Access Compliance Report

Public Rights-of-Way

Intersection ID: 10004304	Main Street: MULLAN_LN	Cross Street: REALTA_DR	Location: SE
ADA ID: C089BC50A90A	Ramp Type: BlendTrans1	Initial Pass/Fail: Fail	Overall Compliance: No
		Severity Score: 10

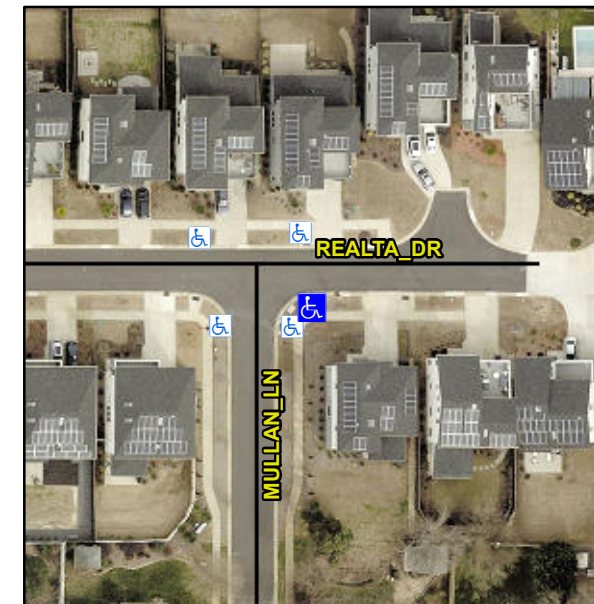
CURB LIP 1.0

Not Found, R304.5.1

Remove & Replace Curb Ramp With Two New Directional Ramps or Equivalent.
